Building Permit Application

Building Address: 1005 High Stepper Trail
City: Sylkesville State: MD Zip Code: 21784
Suite/Apt. #: _____ SDP/WP/BA #: GP19-66
Subdivision: Walker Meadows
Lot: 1 Tax Map: _____ Parcel: F-17-045

MEMORANDUM

RE: **1005 High Stepper Trail**, Potential Basement Bedroom

| 46.1 | <p>NVR, Inc. Services Architectural Services 21 S. Architects Frederick, MD 21702</p> | | <p>10/21/14 11/20/14 12/20/14 1/20/15 4/20/15 5/20/15 6/20/15 8/20/15</p> | | | |

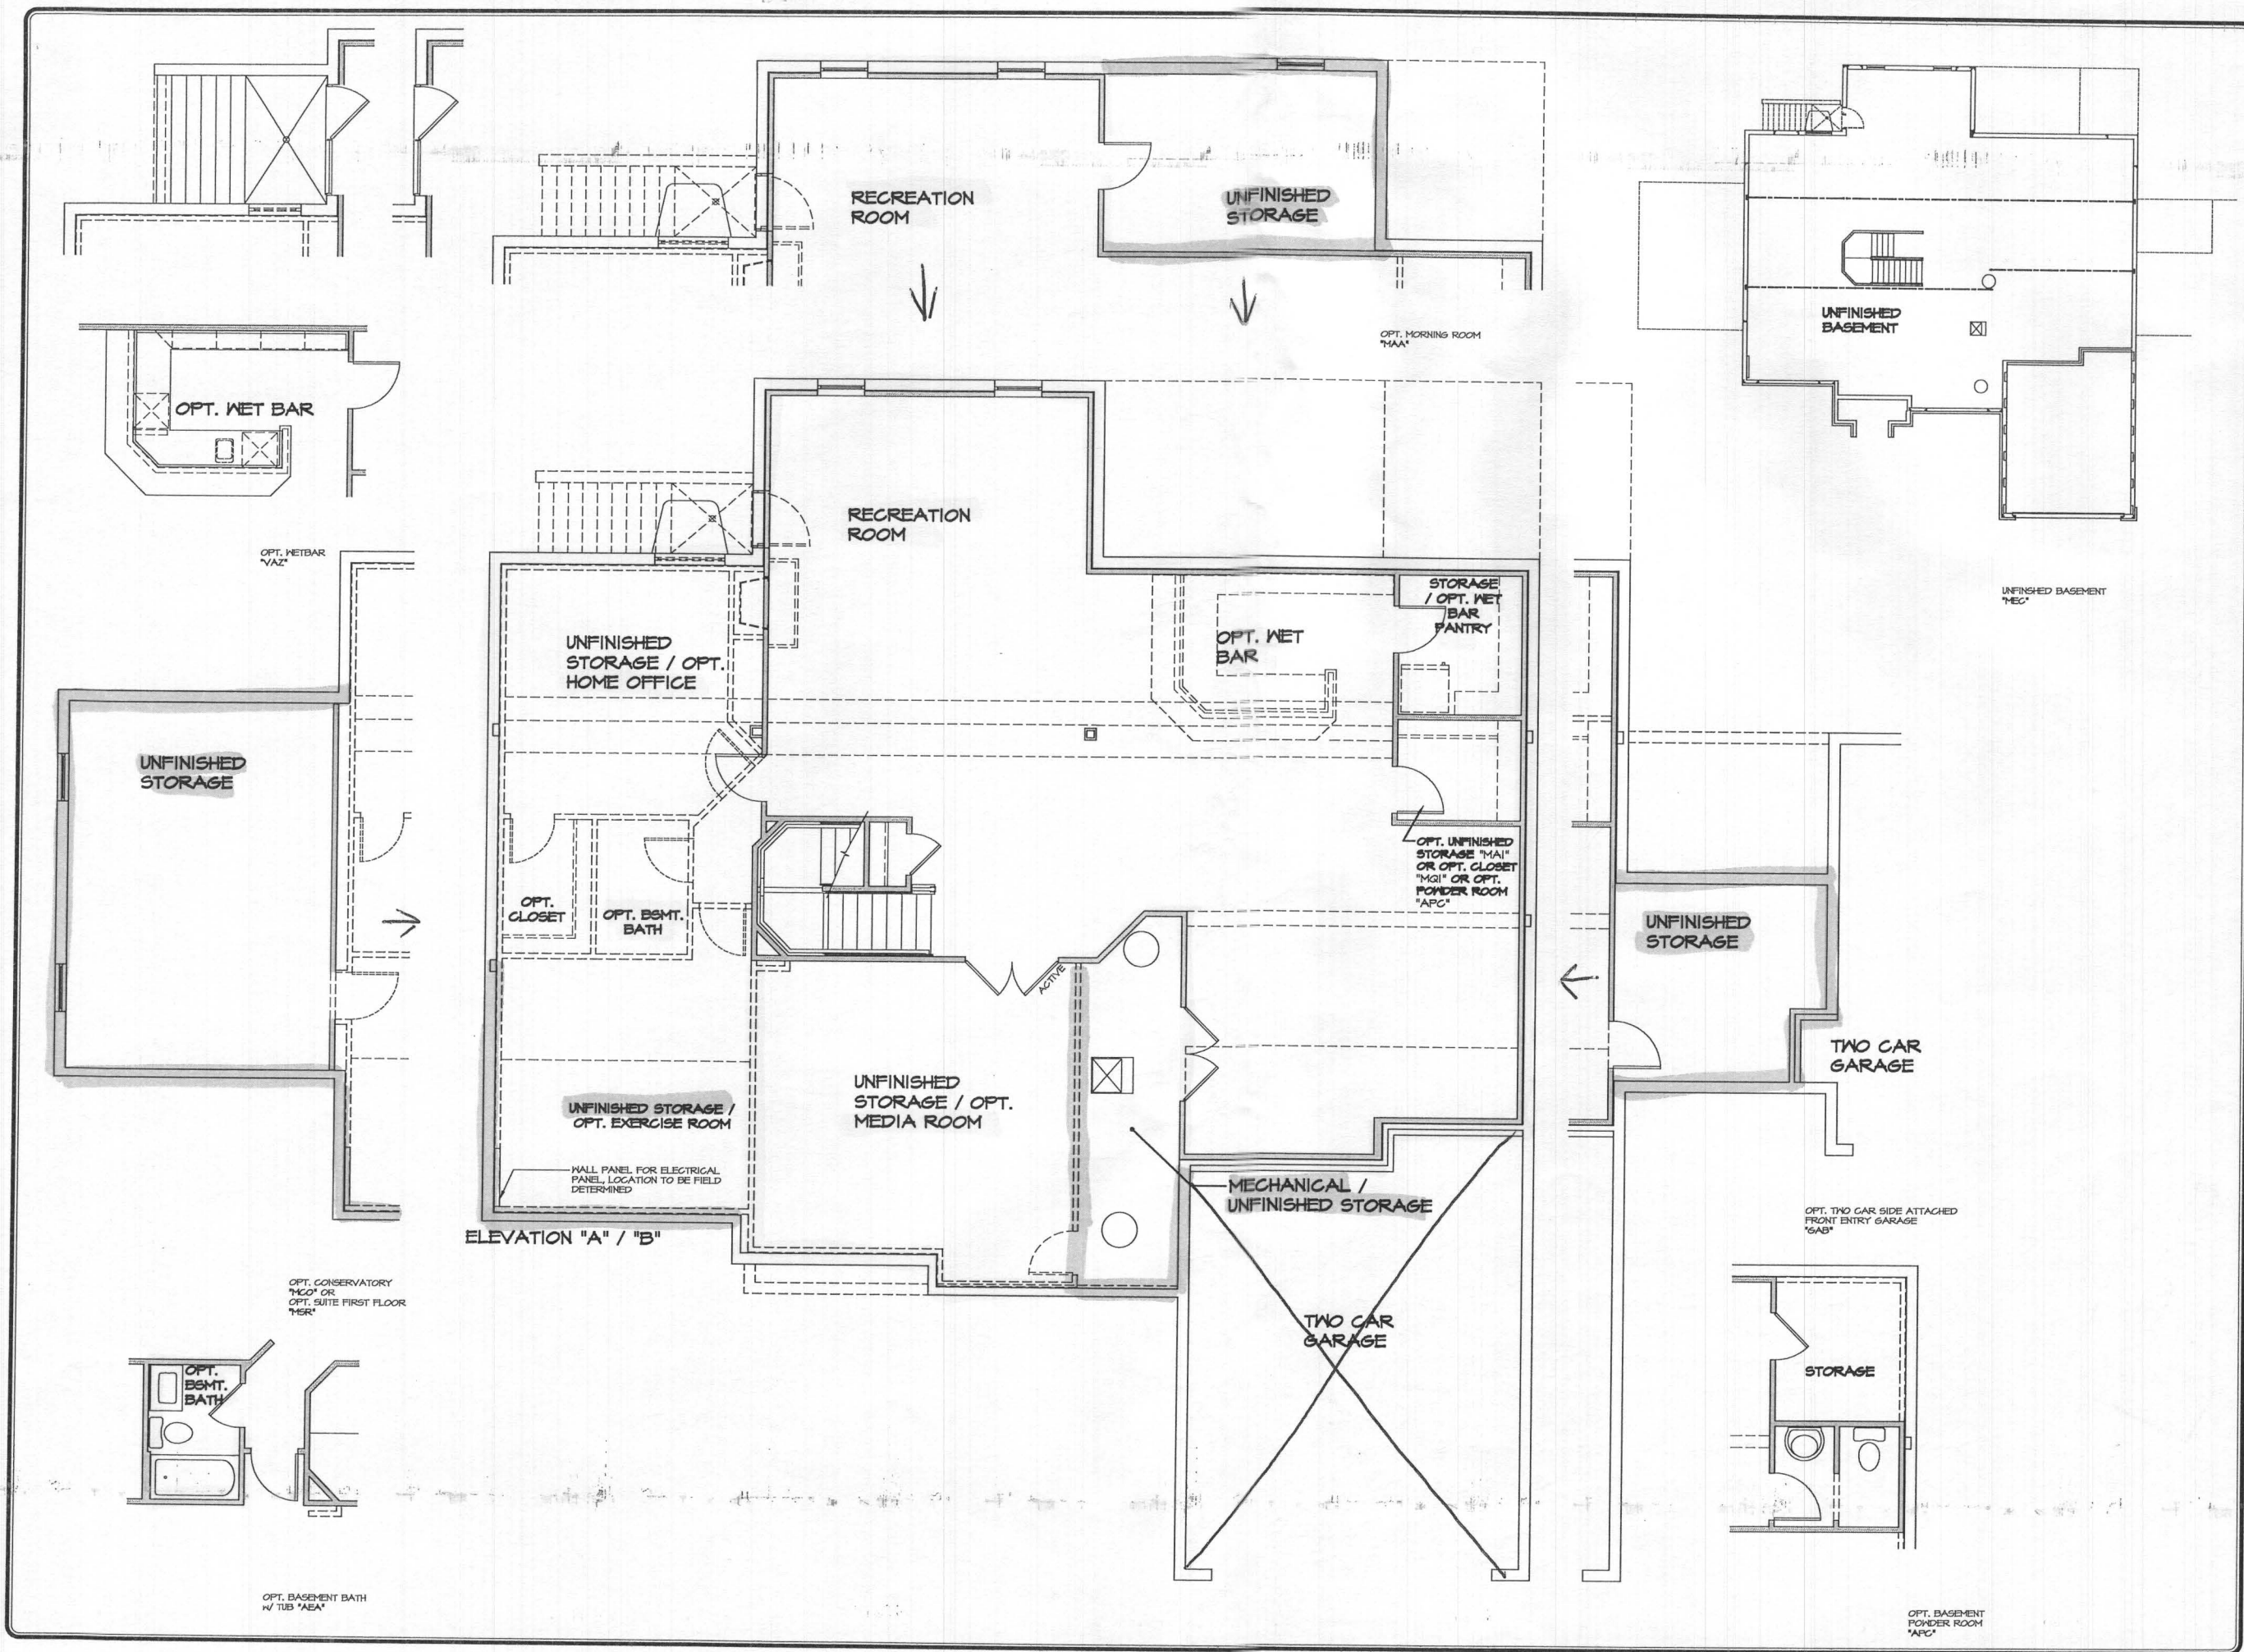
I have reviewed the floor plans in support of Building Permit **B19004355** for a new home at **1005 High Stepper Trail** and noted that there is a full bathroom planned in the unfinished basement. Please note that this makes it very likely for one or more rooms to be considered bedrooms upon conversion of the basement to finished living space.

The Health Department strongly recommends sizing the onsite sewage disposal system at least one bedroom larger than the existing **five(5)**- bedroom design to accommodate a future modification of the finished basement. If you choose to only size for the existing design, any future building permit for modification of the finished basement may be placed on hold until the system is upgraded to accommodate the proposed number of bedrooms. This memo will be retained in the Health Department file for future reference.
